SYDNEY WEST CENTRAL PLANNING PANEL

COUNCIL ASSESSMENT REPORT

Panel Reference	2016SYW082 DA
DA Number	DA/863/2016 (DA/485/2016 – Hornsby Council Reference)
LGA	City of Parramatta
Proposed Development	Demolition of all structures on the site and the construction of two (2) residential flat buildings of six (6) storeys, over two (2) levels of basement, containing 63 residential units, 102 car parking spaces, 20 bicycle parking spaces, two (2) motorcycle spaces, storage, refuse, and communal open space.
Street Address	2-2A Hepburn Avenue & 199-203 Carlingford Road, Carlingford Lots 1 and 2 DP 845101, Lots 1 and 2 DP 879689, Lot 2 DP 30015, and Lot 3 DP 419712
Applicant/Owner	SWA Group
Date of DA lodgement	20 April 2016
Number of Submissions	4
Recommendation	Refusal
Regional Development Criteria (Schedule 4A of the EP&A Act)	Pursuant to Clause 3 of Schedule 4A of the <i>Environmental Planning and Assessment (EP&A) Act 1979</i> , the development has a capital investment value (CIV) of more than \$20 million.

Report date	7 June 2017

Figure 4. breach of building height.

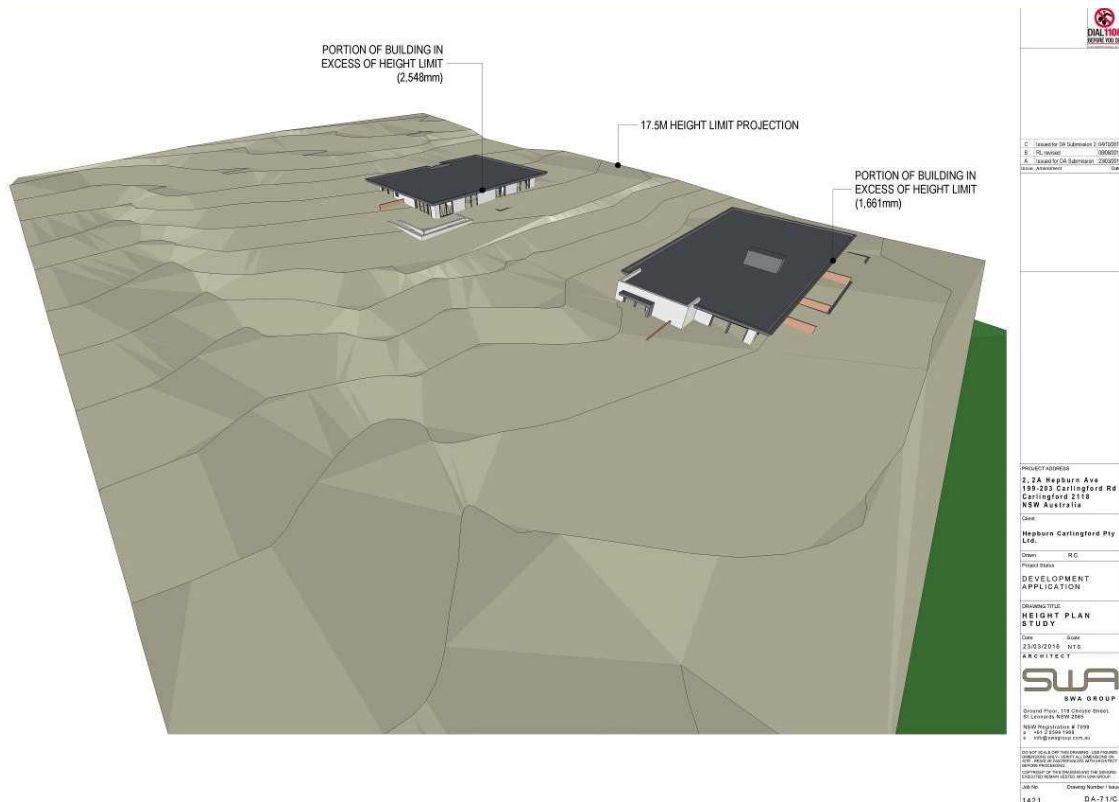
4.3 Height of Buildings	<p>Control: 17.5m</p> <p>Max Height 20.05m</p> <p>Block has a maximum roof height variation of 2.55m and Block B has a roof height variation of 1.8m.</p> <p>This is, however, misleading as a carpark exhaust riser is proposed above the roof level of block B. No height information is provided for this, its shown as approximately 1m higher than the roof on the section drawings, giving an overall height breach of 2.8m to block B.</p>	<p>NO (2.8m to Block B, 16% breach)</p>

The proposal does not comply with the Clause 4.3 'Height of Buildings' development standards as outlined in the table above.

The height and scale of the proposed development is not appropriate for the site. Amenity issues as outlined earlier in this report are as a direct result of the scale of development proposed.

In summary, it is considered that breaching the building height control is not acceptable in this case given the number of amenity issues that would arise if this development were to be approved and constructed.
